COMMONWEALTH OF VIRGINIA  
**COUNTY OF FAIRFAX**  
4100 CHAIN BRIDGE ROAD  
FAIRFAX, VIRGINIA 22030

**STAFF REPORT**

APPLICATION NUMBER FDP 78-P-130-3  
and SE 82-P-103  
PROVIDENCE DISTRICT

**Applicant:** Sequoia Building Corporation

FDP 78-P-130-3

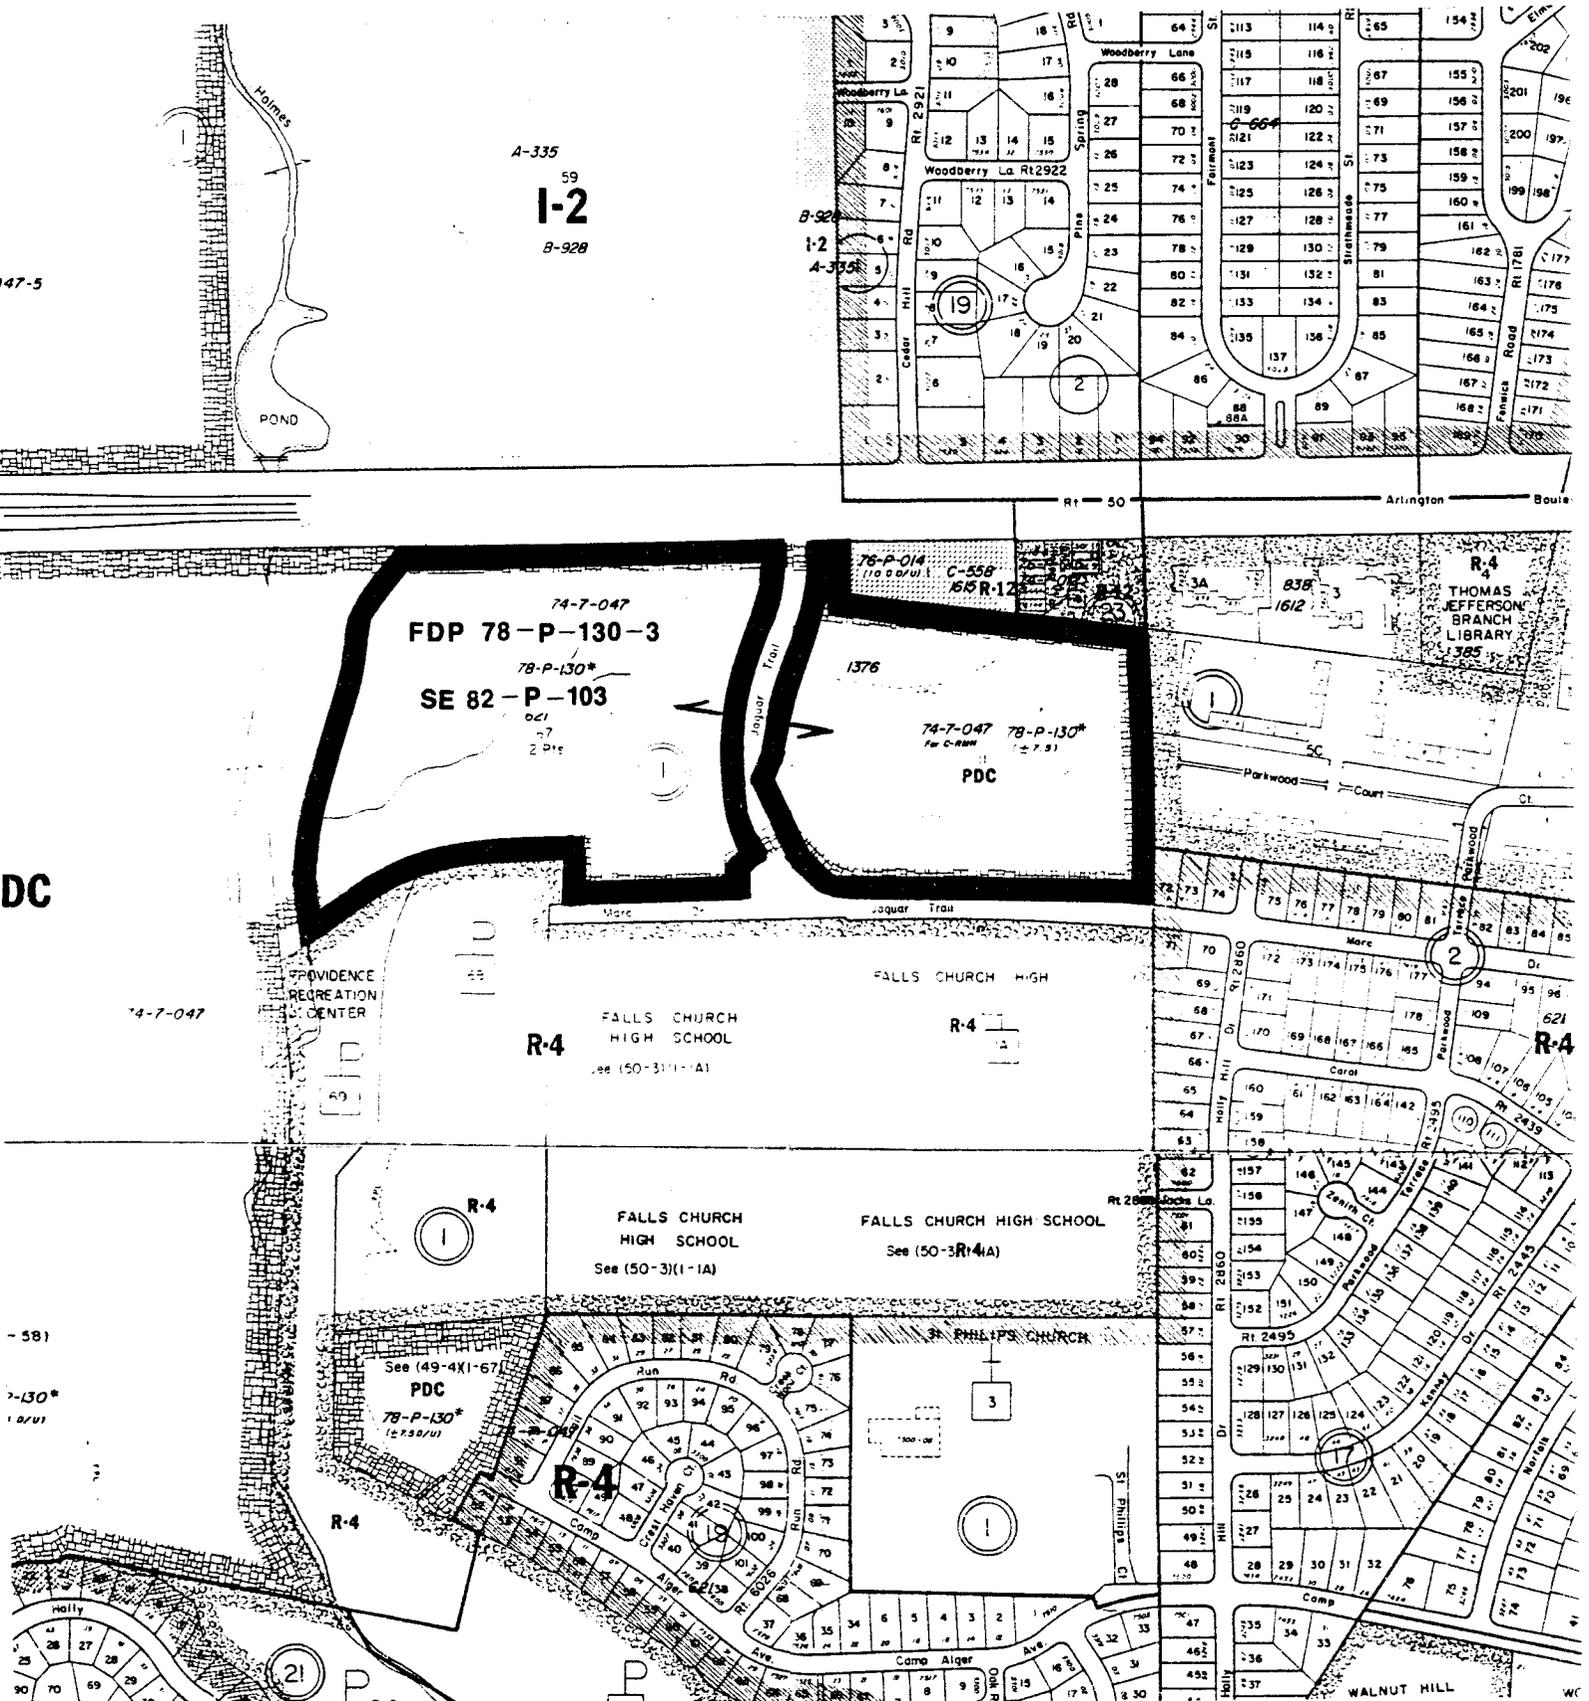
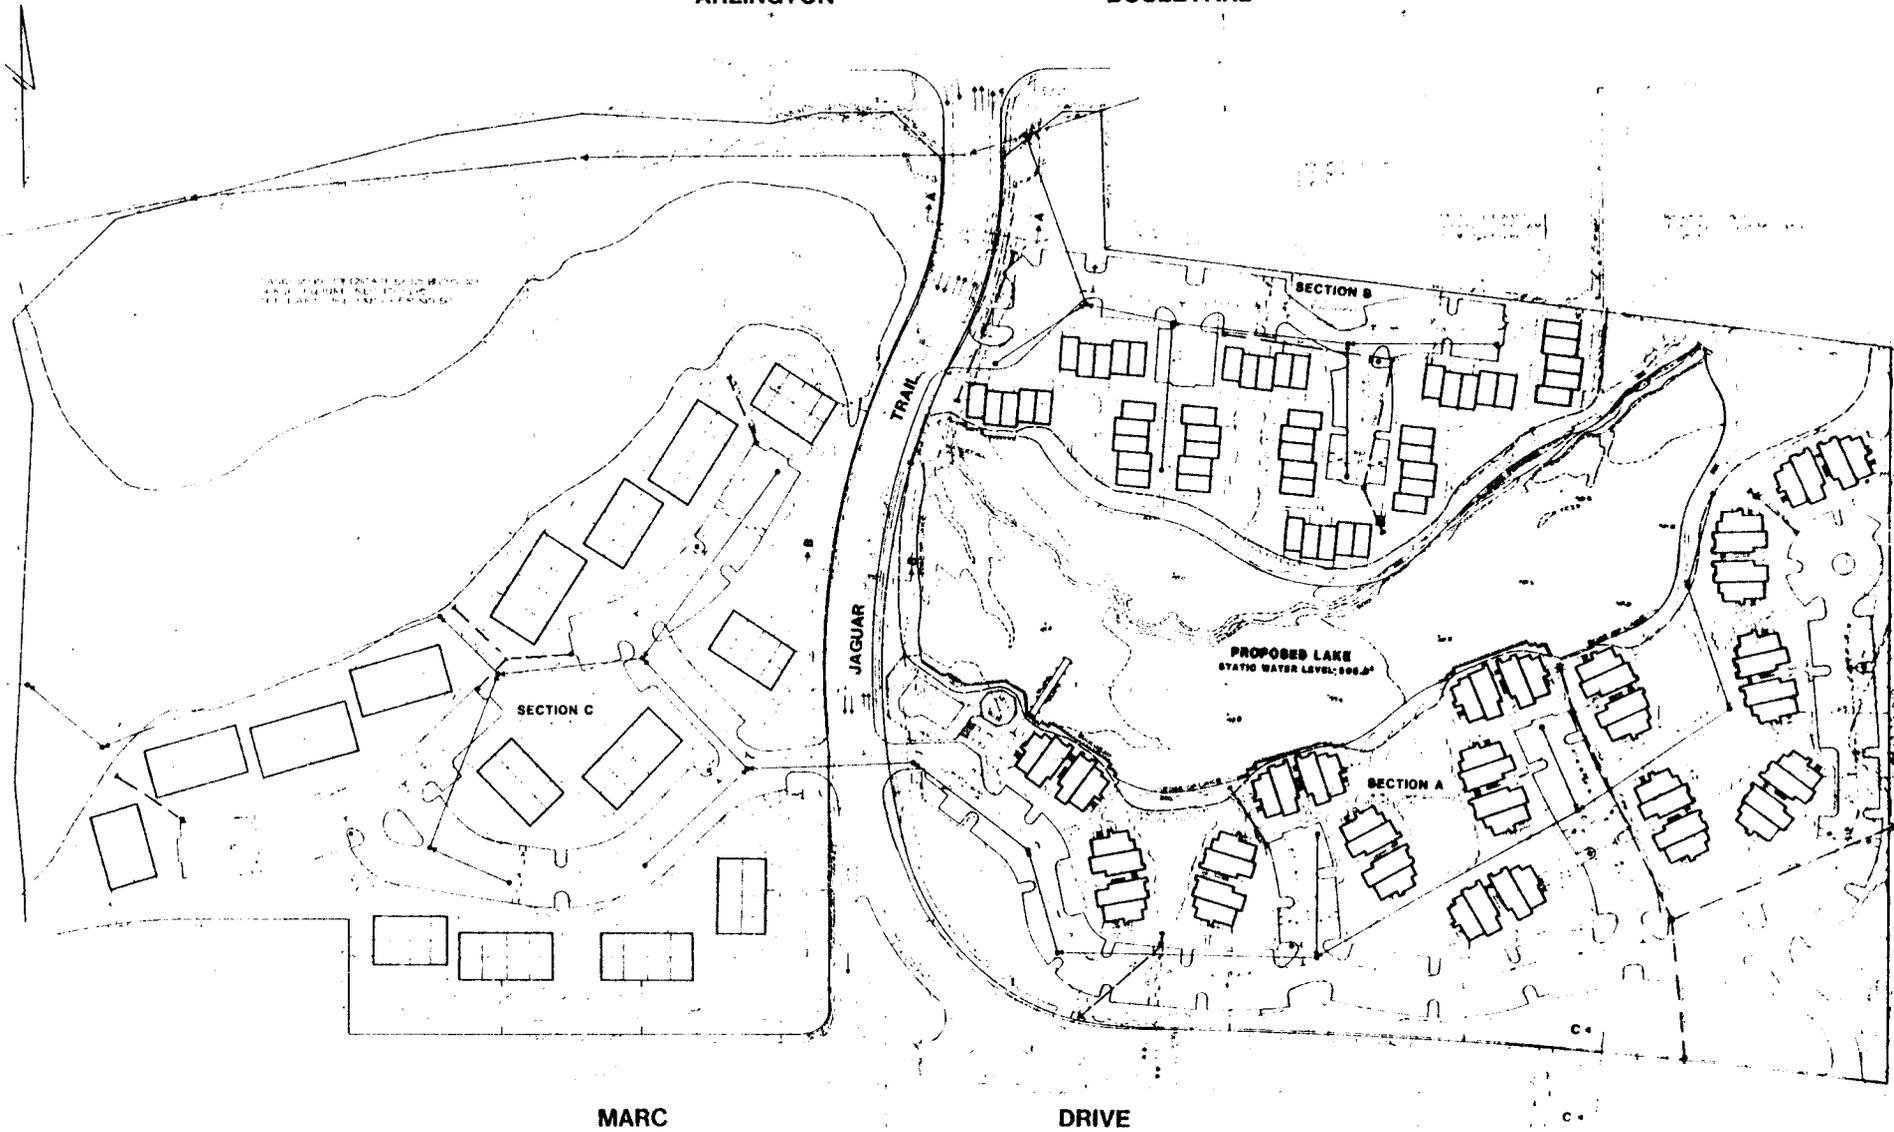
The applicant's submission materials have not addressed the maintenance of the proposed lake nor its weir/dam. The maintenance of these facilities should be the strict responsibility of the applicant/owner of the property. Maintenance costs for the lake would not be expected to be high. In order to further minimize these costs the design of the lake is such that maintenance requirements are kept to a minimum.

Because the applicant proposes to use Jaguar Trail as the dam for the proposed lake, and because Jaguar Trail is proposed for improvements sufficient for acceptance for maintenance purposes by the VDH&T, final approval of the proposed dam should be subject to VDH&T approval. Though there have been discussions with the VDH&T regarding this matter, no approval has been granted the design. Should the VDH&T reject the proposed use of Jaguar Trail as a dam

for the lake, a modification of the lake design to permit the construction of a dam located east of the road may occur. The Code of Virginia provides that the maintenance of dams over which a road will pass, such as the one proposed by the applicant, be maintained by the owner of the land on which the dam is to exist. The Board of Supervisors is the owner of the land through which Jaguar Trail passess and on which the dam would exist. Though the right-of-way for the road will likely be conveyed to the VDH&T, the legal ownership of the land under the right-of-way would remain with the Board. Even should the VDH&T be amenable to the establishment of Jaguar Trail as a dam for the lake, it is not recommended that the Board assume the responsibility for maintenance of the proposed dam. For this reason the lake should be established by construction of a new dam. This dam should be located wholly outside of the expected right-of-way of Jaguar Trail as well as entirely within the applicant's property.

- o The layout for the proposed garden apartments on the western site has been improved since the initial submissions. Building groups have been clustered and buffered from adjacent streets and structures have been relocated away from sensitive steep slopes adjacent to the floodplain.

- o The proposed layout of the townhouse portion of the development, much like the rest of the eastern portion of the development, is of good quality. It takes advantage of the water as an attractive feature and clusters the units in small groupings. The sole concern with the design of the townhouses involves the grouping closest to Jaguar Trail. The parking facilities for these units would be located across the main entrance driveway. Either these units should be relocated or their parking facilities should be located such that they are more proximate and do not interfere with the safety of the entrance. A resolution of this problem which would locate the proposed entrance closer to Arlington Boulevard would not be appropriate.

- o The application for FDP approval requests that the Board permit twenty-five (25) percent of the parking spaces on the sites to be designated for compact cars. This may be permitted pursuant to Par. 8E of Sect. 11-102 of the Zoning Ordinance. However, compact car parking space dimensions may be permitted only when twenty (20) square feet of landscaped area is to be provided for each space to be reduced. Though the development, as a whole, would have large portions of open space, the applicant has not shown how the required additional 40,000 square feet of landscaping would be provided. Prior to final site plan approval, the applicant should demonstrate where these additional 40,000 square feet of landscaping will be provided. An enforcement plan for the regulation of the usage of the compact spaces should be submitted for Board approval prior to any final approval of this request. Therefore, approval of this request should be deferred until such a plan is submitted by the applicant.

- o The application also requests a waiver of the 15 foot setback from a floodplain requirement of Sect. 2-415 of the Zoning Ordinance. Because the applicant proposes to construct an impoundment with a permanent water surface, a modification of this requirement would be appropriate.

1. Development of the property will be performed in conformance with the adopted Conceptual Development Plan Conditions.
2. That portion of the western half of the site located north of the limits of the floodplain as shown on the Final Development Plan will be conveyed to the Fairfax County Board of Supervisors.

6. Maintenance of the lake and dam shall be the responsibility of the applicant/owner of the property.
7. Should the design of the dam prove unacceptable to the VDH&T, or the Director of the Department of Environmental Management, or the Department of Public Works, any alternative design shall have the approval of the Fairfax County Planning Commission prior to final site plan approval of any portion of the development.

8. The grouping of townhouses proposed to be located nearest Jaguar Trail, as shown on the Final Development Plan, will be redesigned such that pedestrian access to appurtenant parking spaces is available without a crossing of the entrance travel aisle and such that vehicles parking in these spaces do not interfere with the free flow of vehicles at the entrance to the development.
